Hunshelf Park, Stocksbridge

*Stage 1 Road Safety
Audit Report*

October 2017

Problem: 3.1

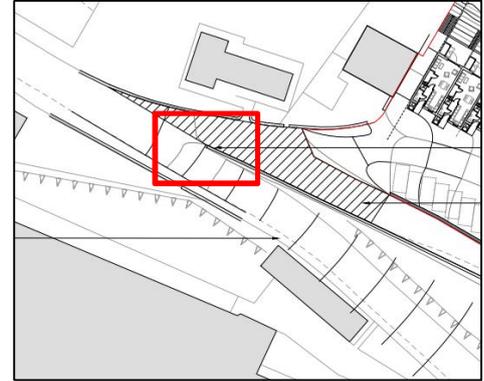
Summary: Risk of injury to pedestrians and / or vehicle occupants due to low level retaining wall resulting in an inadequate barrier protection.

An existing, low height, retaining wall extends from the Hunshelf Park / Hunshelf Road junction, east, along Hunshelf Road. A note on drawing 3286 100 P 001A states that the proposal includes the '*lowering of the retaining wall to the lower side of the entrance*'.

The Audit Team has concerns that lowering the retaining wall to the lower side will result in a substandard provision of barrier between Hunshelf Road and Hunshelf Park. As such, there is a risk that pedestrians, especially children or visually impaired, may walk too close to the edge of the carriageway and fall down the embankment, potentially causing injury.

Furthermore, there is a risk that the resultant height of the retaining wall wouldn't provide suitable vehicle restraint. As such, should a motorist lose control of their vehicle, there is a possibility that an errant vehicle could veer from the road, down the embankment, possibly resulting in injury to all occupants of the vehicle.

Provide a vehicle / pedestrian restraint system to provide barrier protection in accordance with design standards.

Problem: 3.2

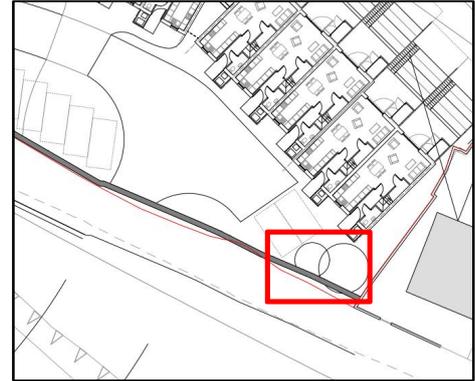
Summary: Loss of parking provision may result in parking activity within unsafe locations, causing obstruction or obscuring forward visibility to oncoming motorists.

Drawing PT118-103 PL01 shows the extents of the housing development, including the length of retaining wall, located between the parking bays and Hunshelf Park. During the site visit, the Audit Team noted that the area of land, indicated above, is used as a car park by local residents. However, the proposal requires this land.

The Audit Team has concern that the loss of parking provision on Hunshelf Park may cause local residents to park in alternative, unsafe locations, causing obstruction which may result in side swipe collisions or obscuring forward visibility to other motorists. This issue creates a greater risk, should pedestrians on Hunshelf Park, masked by parked vehicles; step out into the path of an oncoming vehicle, as this may result in injury.

Realign the proposed wall to avoid removal of the existing parking area, or provide safe, alternative parking provision.

Problem: 3.3

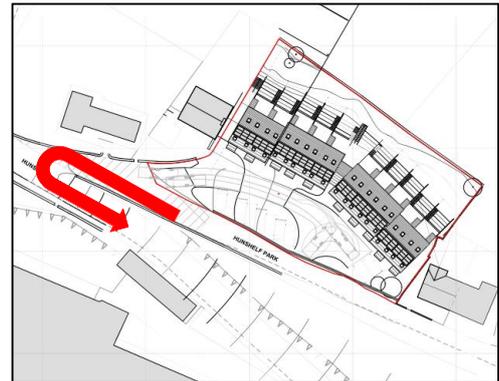
Summary: Risk of collision between parked vehicles and larger vehicles accessing the housing development.

Drawing 3286 100 P 005A shows the location of the ten residential parking bays and a swept path analysis for a 'Dennis Eagle 6 x 2RS refuse vehicle' accessing the housing development.

The Audit Team has concerns regarding the swept path of the refuse vehicle and its close proximity to 'Bay 1'. There is a risk that a when parked, a vehicle in Bay 1 may overhang the marked area and encroach into the swept path, causing an obstruction to any vehicle passing. This may result in injury to anyone in the moving vehicle and damage to both vehicles involved.

Realign / reposition the parking bays or realign the access road to avoid potential conflict.

Problem: 3.4

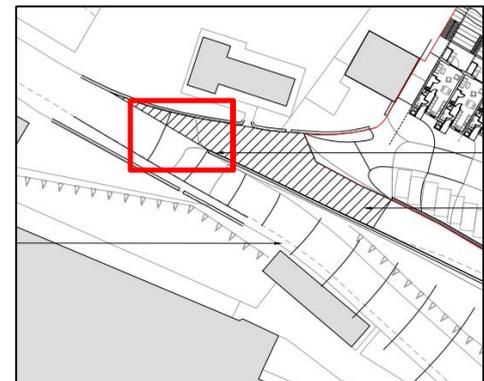
Summary: Risk of head on collisions between motorists turning onto Hunshelf Road and oncoming motorists, resulting in injury to occupants of all vehicles, due to junction radii.

Drawings 3286 100 P 004A and 3286 100 P 005A both show the swept path analysis for refuse vehicle manoeuvres at the residential site / Hunshelf Park junction. However, there is no evidence to show the swept path analysis for vehicle manoeuvres at the Hunshelf Park / Hunshelf Road junction.

Based on observations made and from personal experience, the Audit Team has concerns with the tight radii for motorists to negotiate the turning manoeuvres at the Hunshelf Park / Hunshelf Road junction, particularly those making the left turn onto Hunshelf Road. As activity / traffic flow to and from Hunshelf Park will increase due to the additional housing, there is an increased risk of a head on vehicle collision between a motorist making the left turn manoeuvre and an oncoming, north-westbound, motorist. This may result in injury to occupants of all vehicles involved.

Provide a swept path analysis to demonstrate that all turning movements at the Hunshelf Park / Hunshelf Road junction can be accommodated safely.

Problem: 3.5

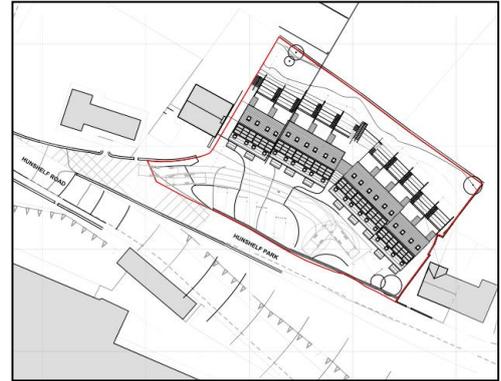
Summary: Risk of head on collisions between motorists turning onto Hunshelf Road and oncoming motorists, resulting in injury to occupants of all vehicles, due to limited visibility.

Based on the information provided and observations made on site, the Audit Team has concerns regarding the forward visibility at the Hunshelf Park / Hunshelf Road junction. The alignment of the junction is such that forward visibility of oncoming vehicles, particularly for motorists turning onto Hunshelf Road, is poor. Motorists were observed to position their vehicle beyond the junction in order to see oncoming traffic. There is a risk that this will cause head on collisions between motorists turning onto Hunshelf Road and those approaching from either direction, possibly resulting in injury to occupants of all vehicles involved.

Provide evidence to show that the required visibility splays are provided at the Hunshelf Park / Hunshelf Road junction.
